## **ADDENDUM NO. 2**

- A. Date: 22 March 2012
- B. From: Bahr, Vermeer and Haecker Architects, Ltd.
- C. To: Prospective Bidders.
- D. Project: Wilber-Clatonia High School Ceiling Remodel  
Wilber, Nebraska
- E. This addendum is issued by the Architect to all bidders of record prior to receipt of proposals. Bidders shall acknowledge receipt of this addendum by so indicating on the Bid Form. Failure to do so may subject Bidder to disqualification.
- F. All information and instructions given herein shall become a part of the Contract Documents.
- G. This Addendum contains 3 total pages with 7 attachments.

**Wilber-Clatonia  
High School  
Ceiling Remodel**

**PARTIAL FIRST FLOOR REFLECTED CEILING  
PLAN - AREA A**

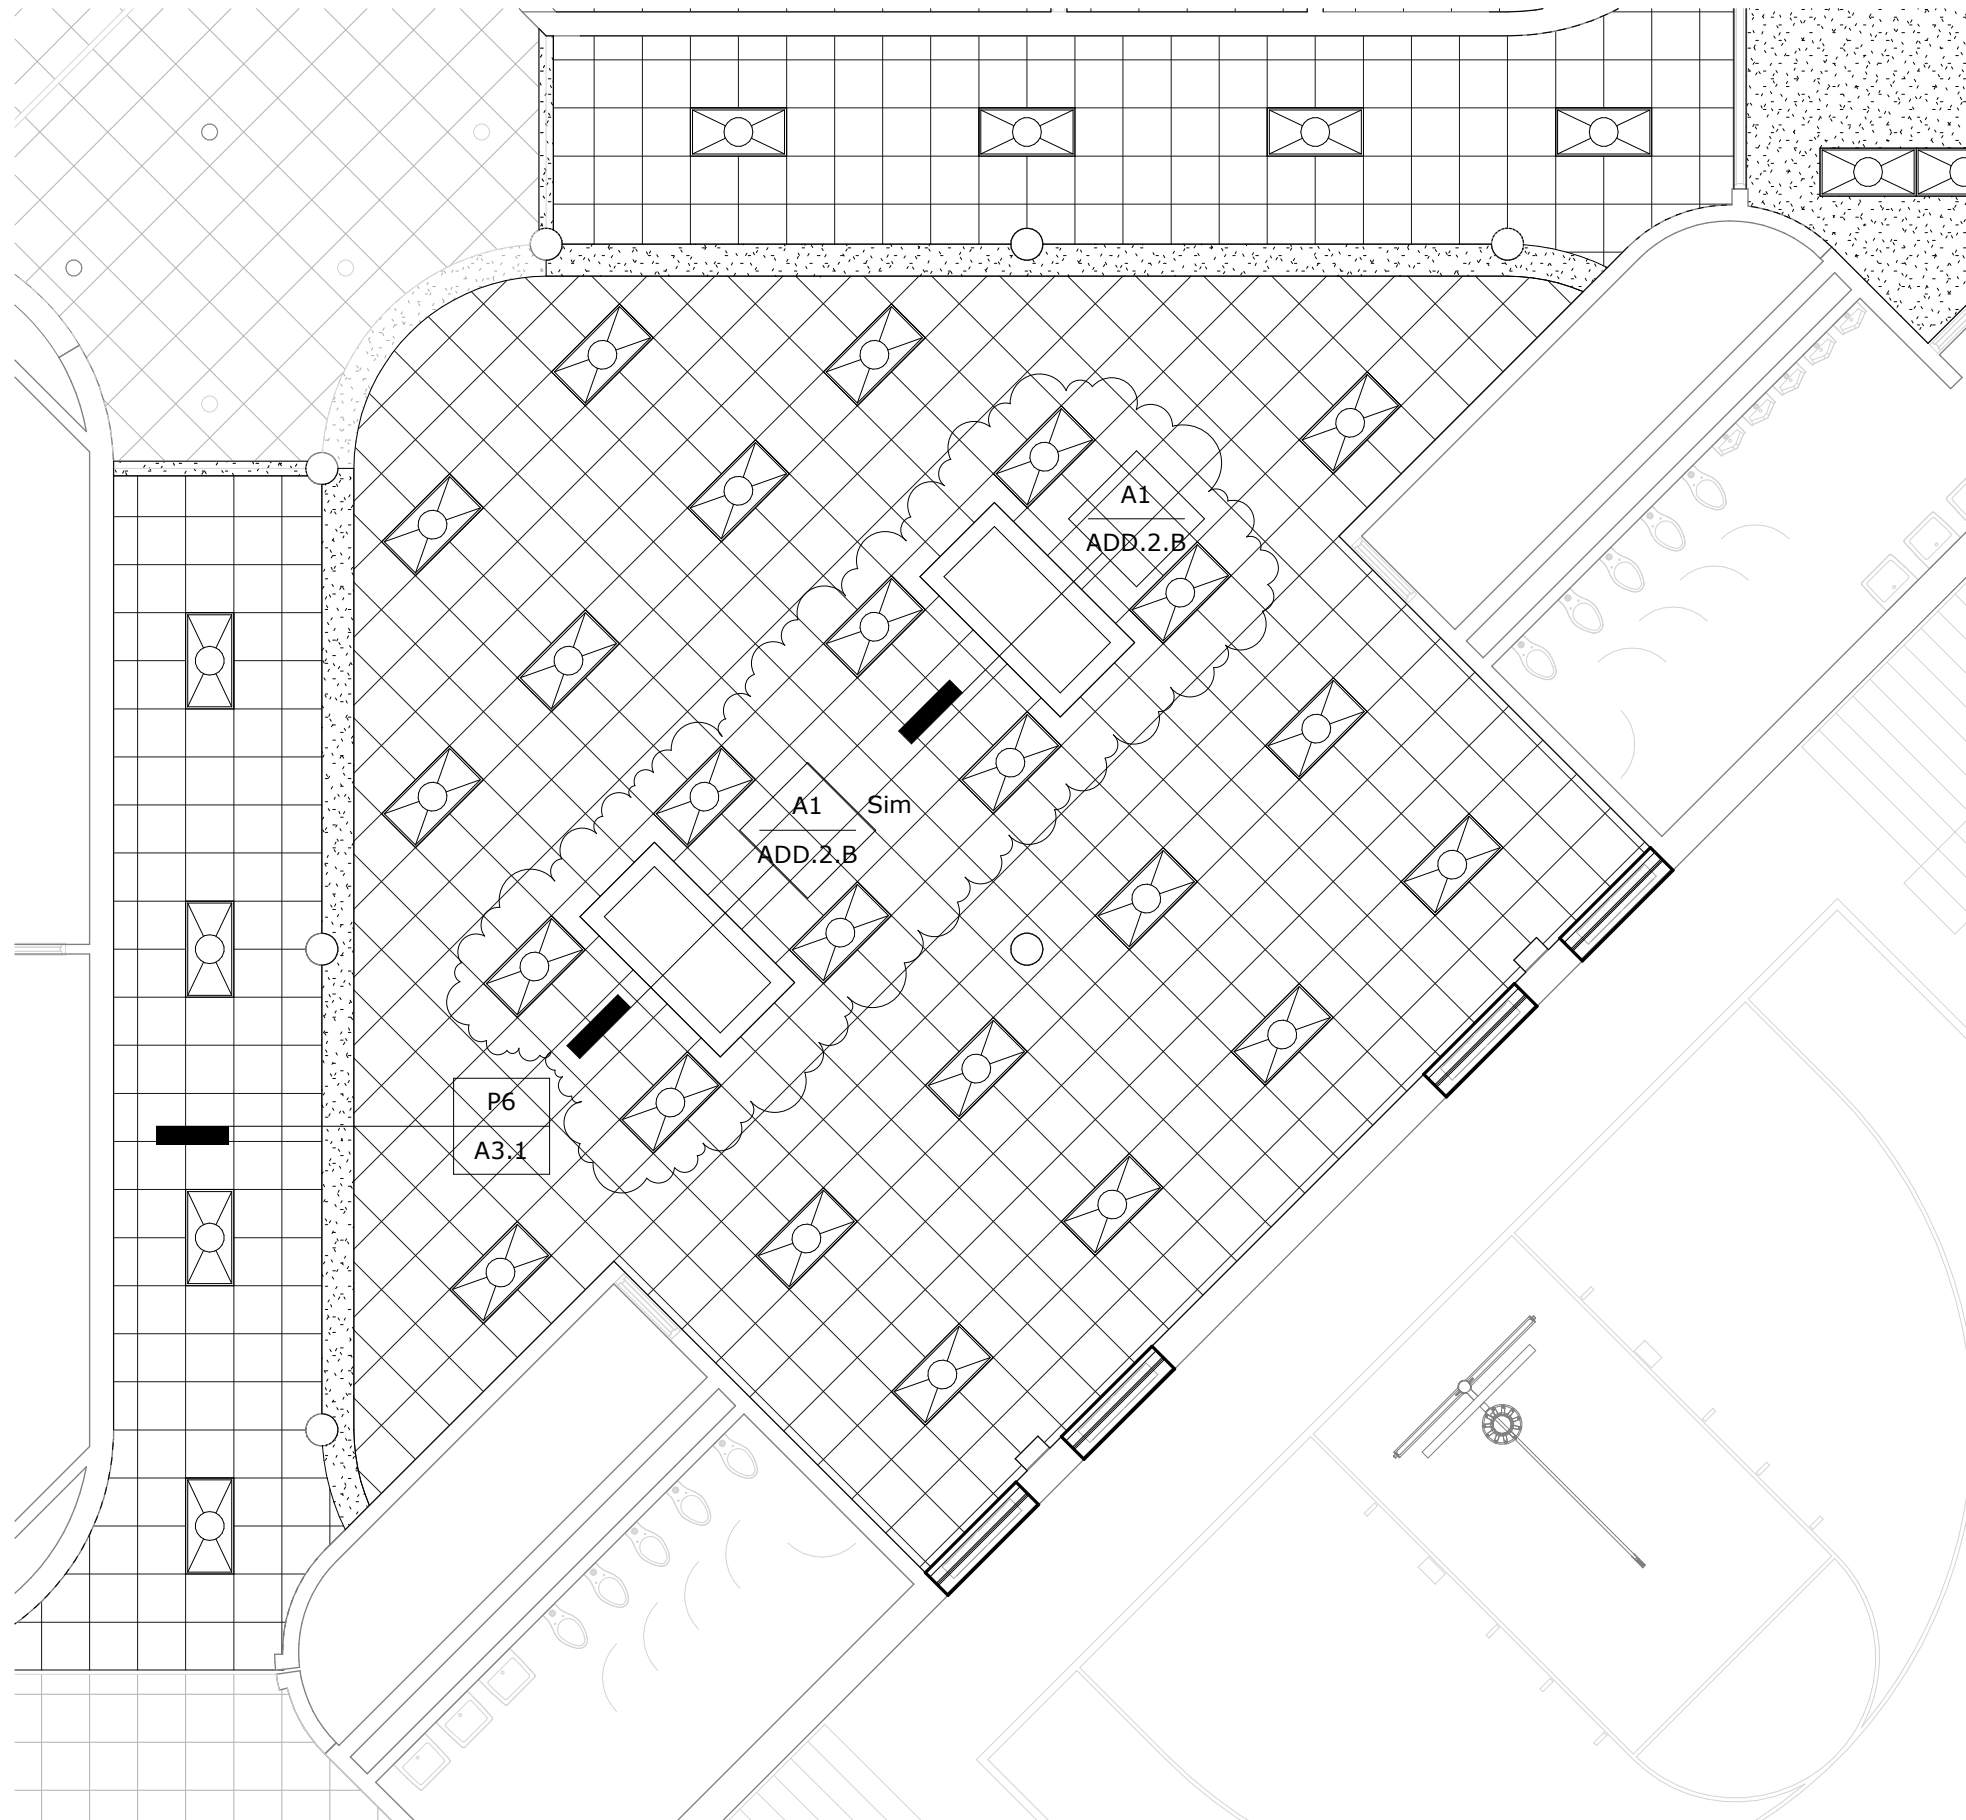
- A. Sheet A2.2 – First Floor Reflected Ceiling Plans
  - 1. Reference Drawing A1 – First Floor Reflected Ceiling Plan;
    - a. Delete all of the Sheet Note Tags referencing to the rooms west of Corridors E22 and E88.
    - b. See Attachment “A” for the revised partial reflected ceiling plan for Commons E49. Two new gypsum board skylight shafts and translucent assembly skylights were added in this room. All the work associated with the two translucent skylights shall be included in Alternate No. 3.
